JUMPER CARTER SEASE/ARCHITECTS, P.A.
412 MEETING STREET, WEST COLUMBIA, SOUTH CAROLINA 29169
(803) 791-1020 (803) 791-1022 FAX

UNIVERSITY OF SOUTH CAROLINA CAPSTONE CAMPUS ROOM UPGRADES

PROJECT NO: 11103

ADDENDUM 02

1
1-7
CEILING DETAIL
SCALE: 1 1/2" = 1'-0"

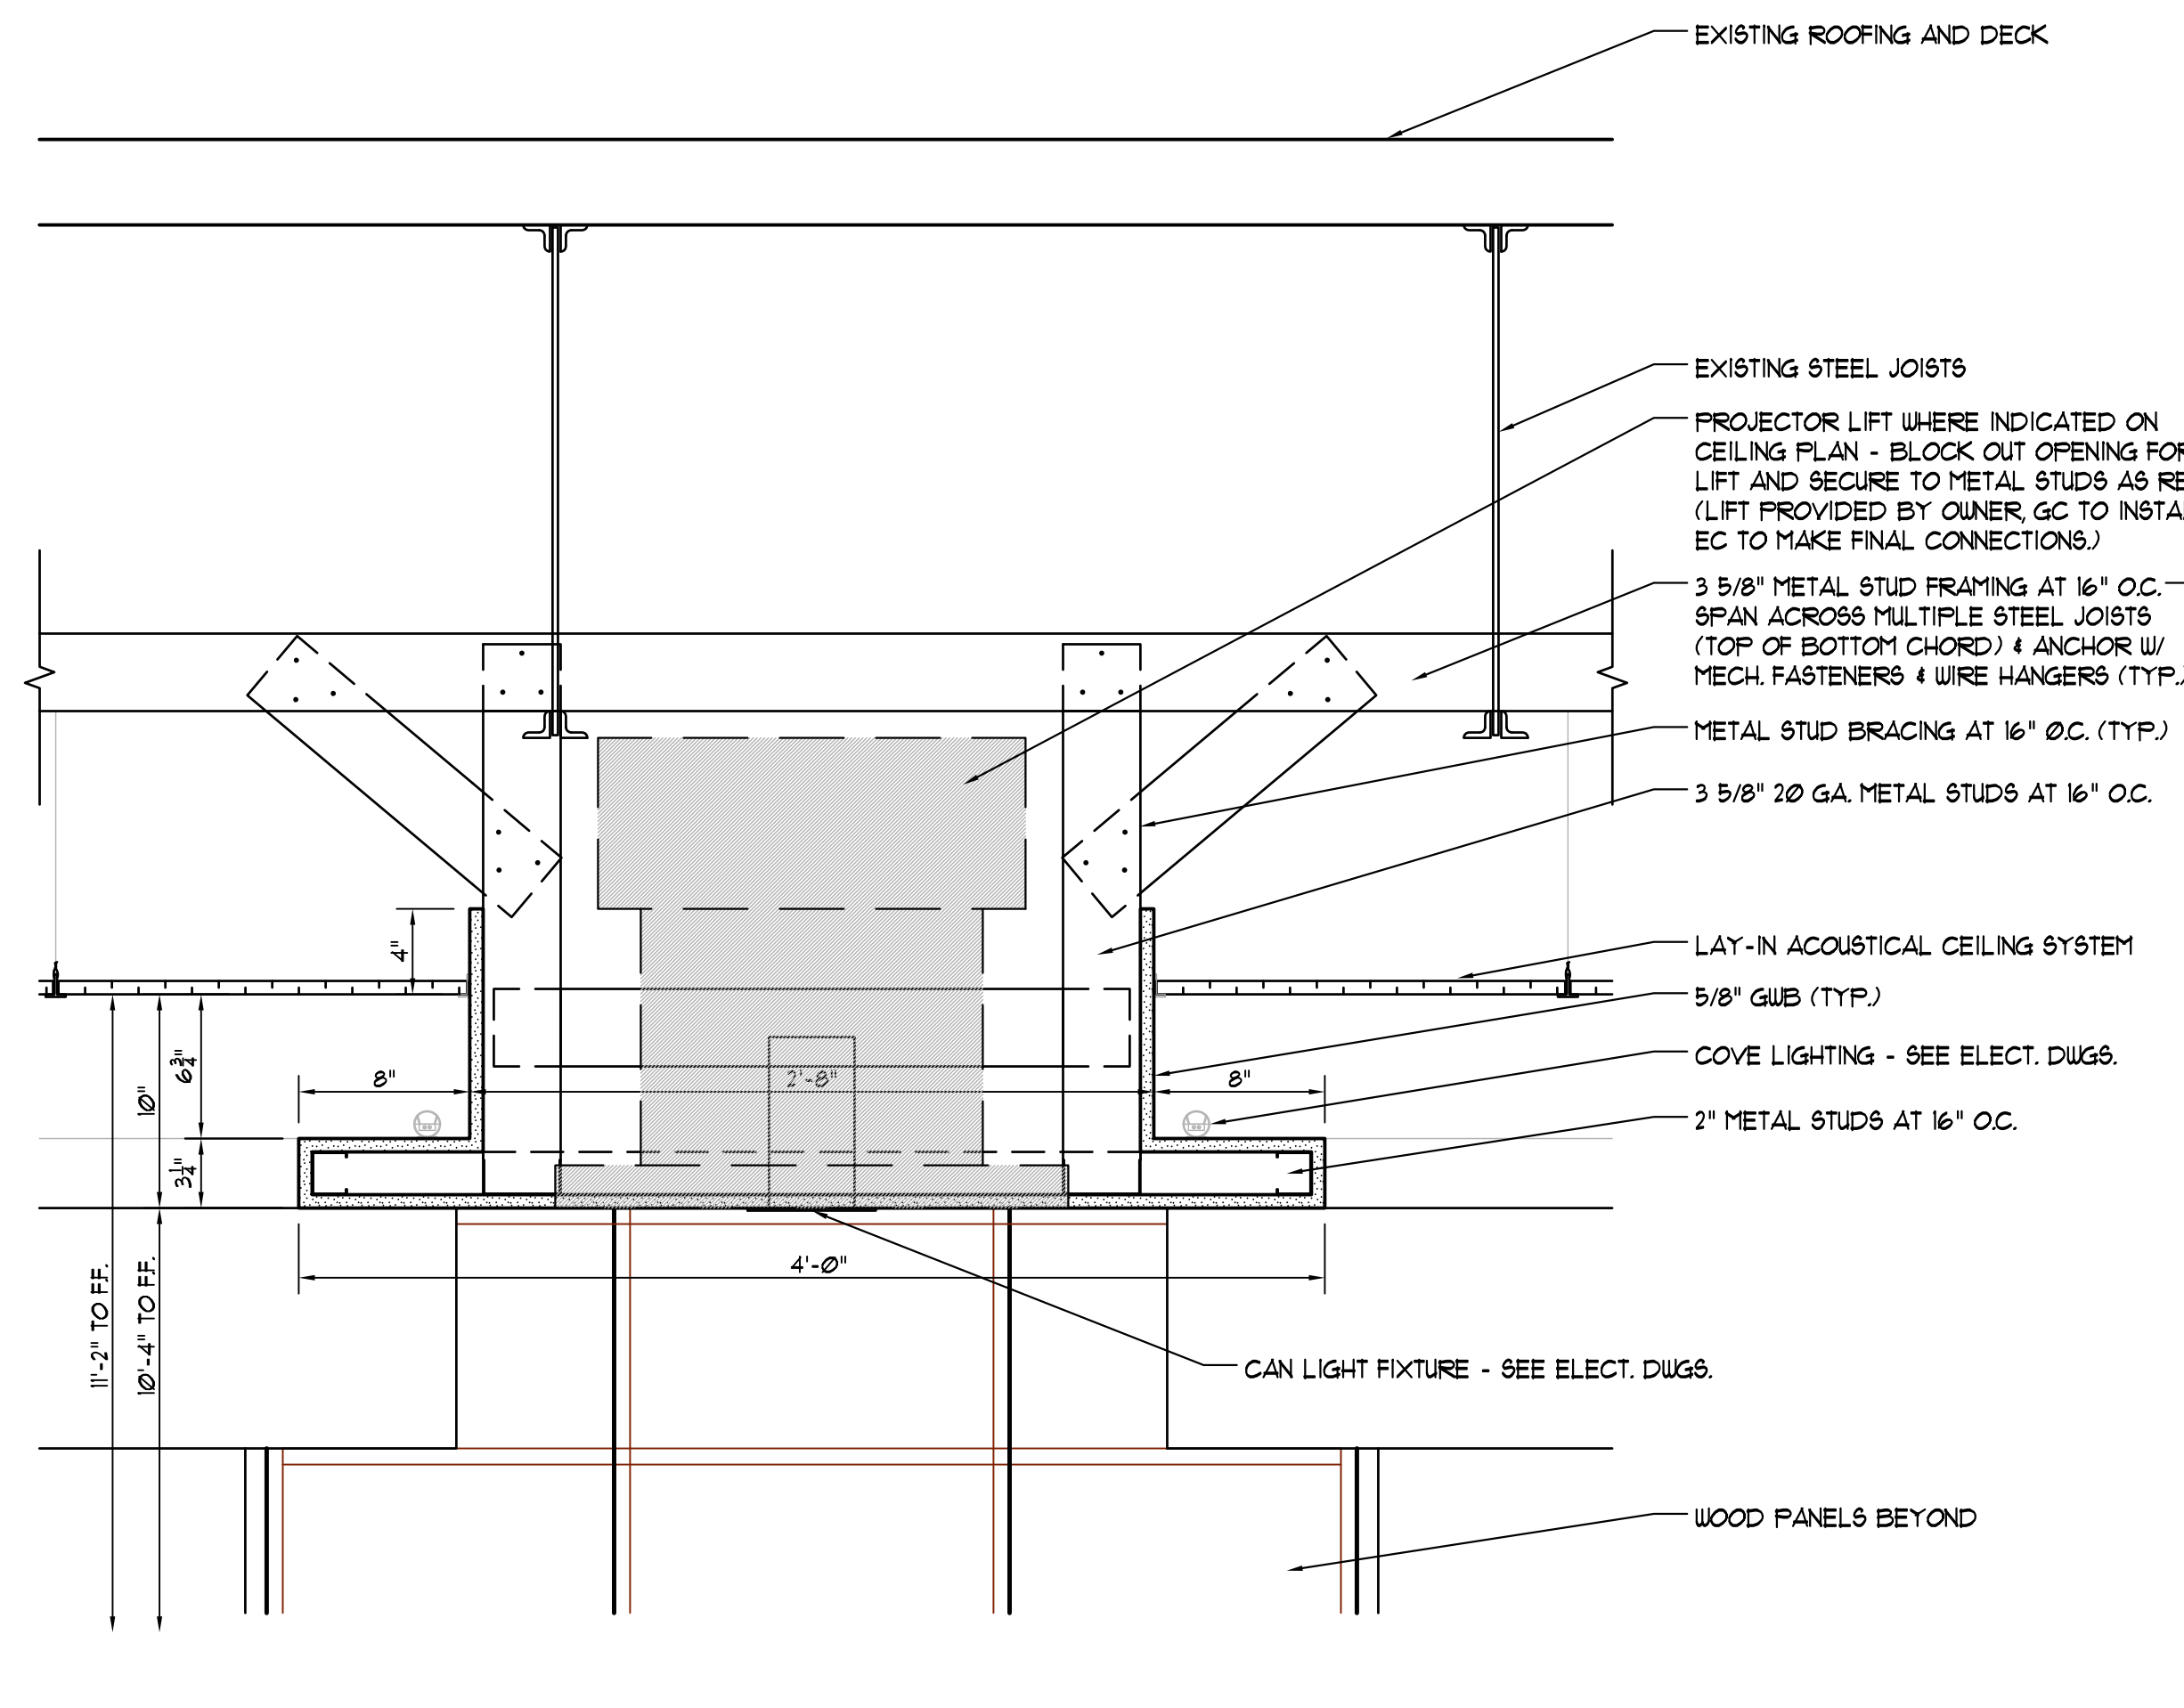
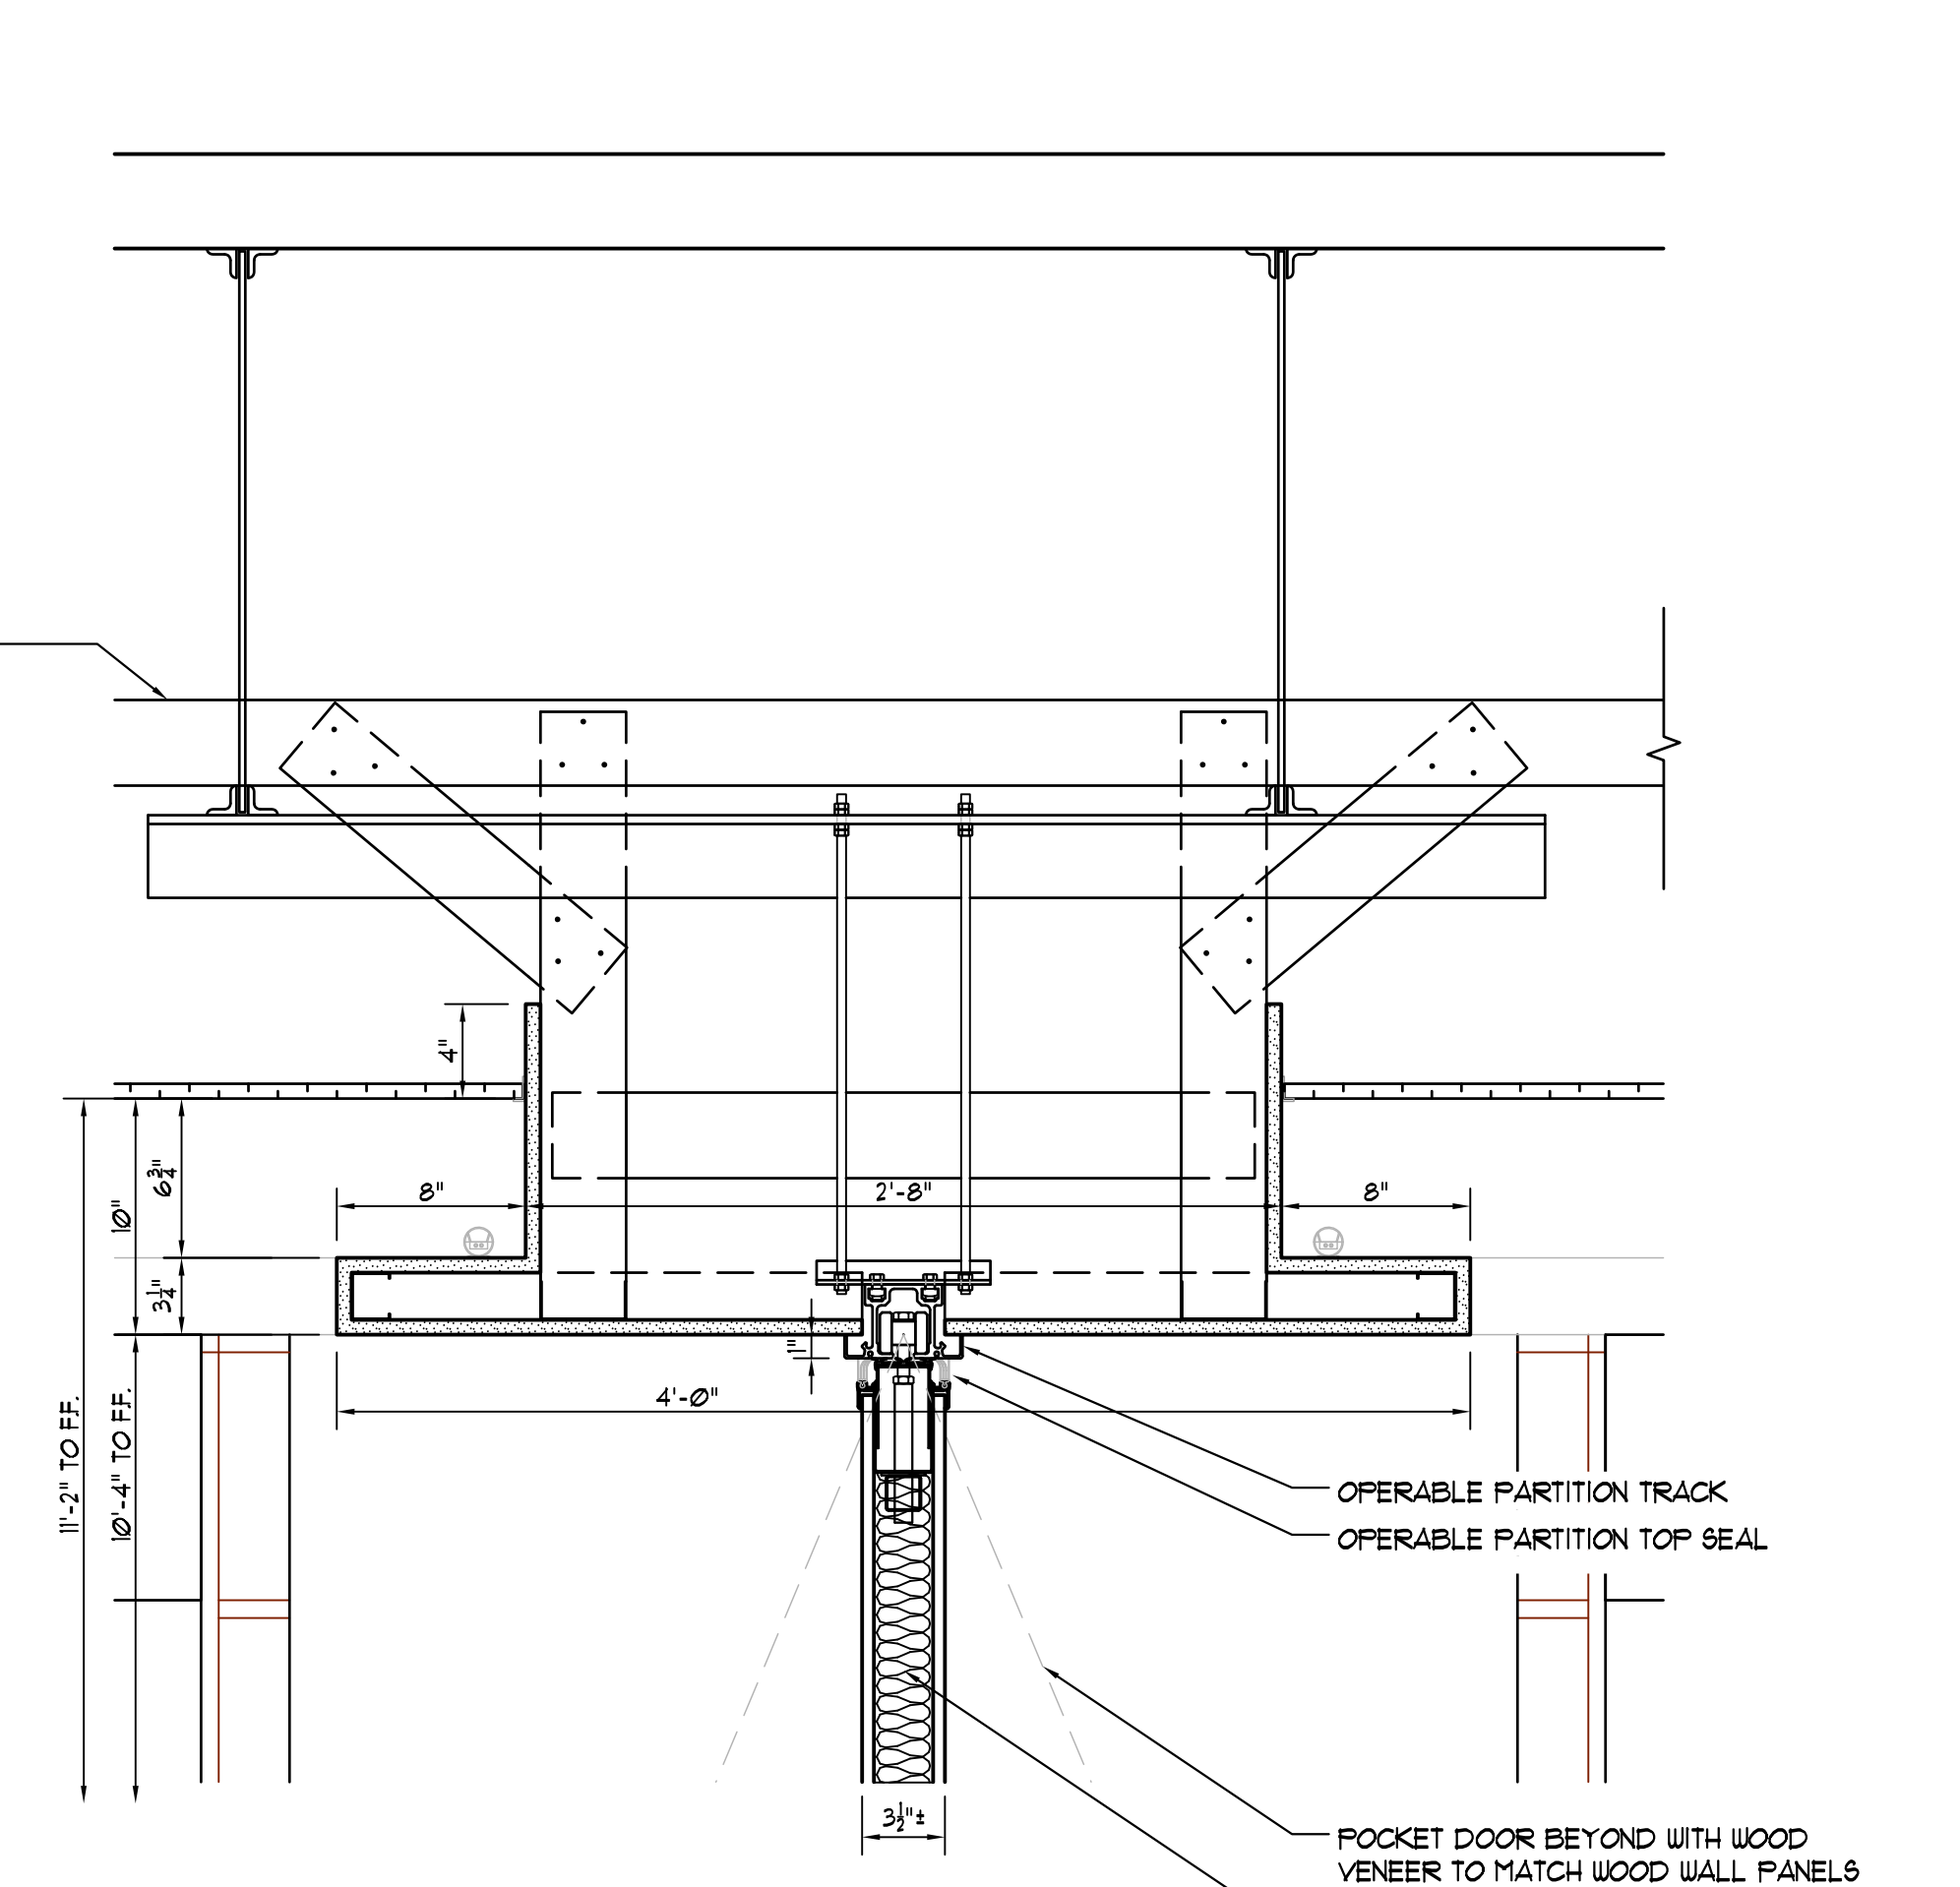
- 1. Drawing I-7 CEILING DETAILS: OMIT** Drawing I-7 and **REPLACE** it with NEW DRAWING I-7.
- 2. Drawing I-5 DOOR & FINISH SCHEDULES / COLOR SCHEDULE / DOOR & WINDOW TYPES & DETAILS / PANEL DETAILS; CHANGE** Wood Veneer Panel Reveal Details as shown.
